HISTORIC DISTRICT COMMISSION NOTICE OF DENIAL

Application Number: HDC2025-00418

PROJECT ADDRESS: 1485 Burns Avenue

Replace storm window with vinyl casement window

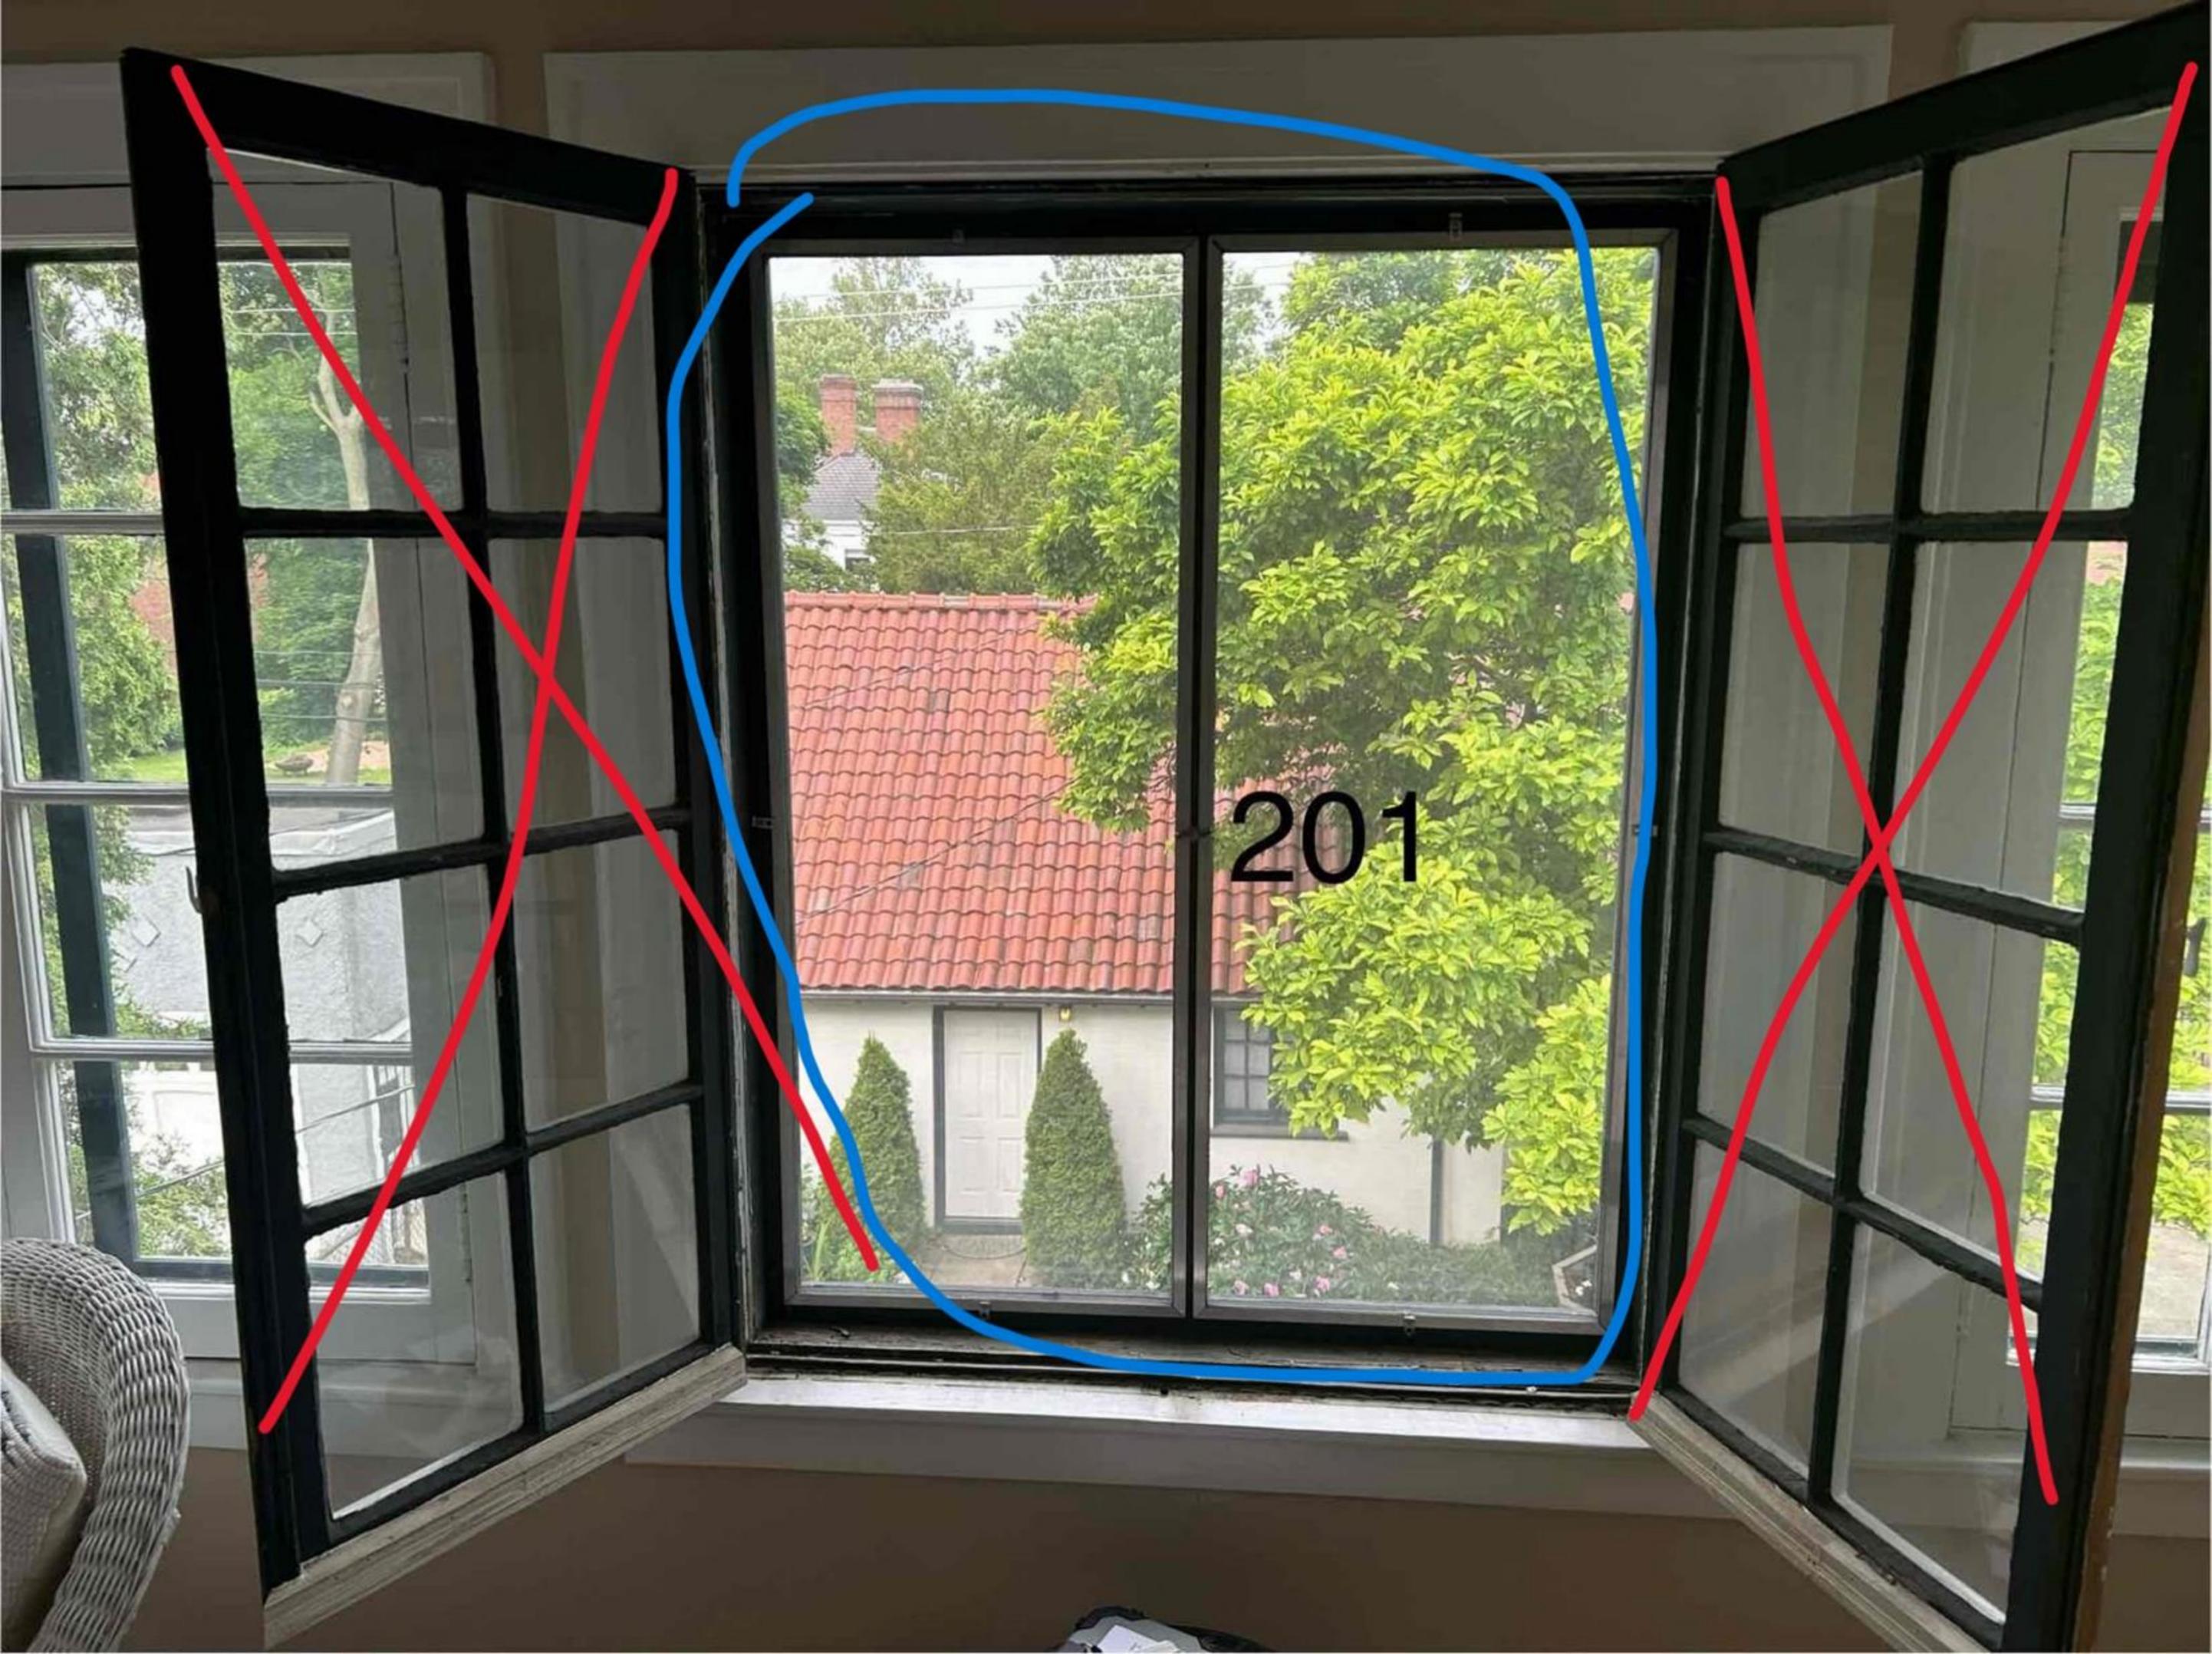
You have mentioned that you want to replace existing storm doors but our assessment found your application confusing because the proposed new window does not appear to be like-for-like. The proposed window show a white, vinyl casement window on the outboard.

Staff does have the authority to approve new storm doors (though white vinyl will not be appropriate), but not the authority to approve an addition of a new outboard window to the exterior of the window frame (for which the application will have to go to the Historic District Commission). Feel free to clarify and of these issues.

Hello, I spoke to I believe Lise a few days ago and confirmed we are not doing anything with the inner grids only replacing the outer windows. I believe it was stated in my original application that the existing windows on the home are vinyl and the homeowner painted them black and they plan to paint our white vinyl windows black to match the exiting. Provided additional photos.
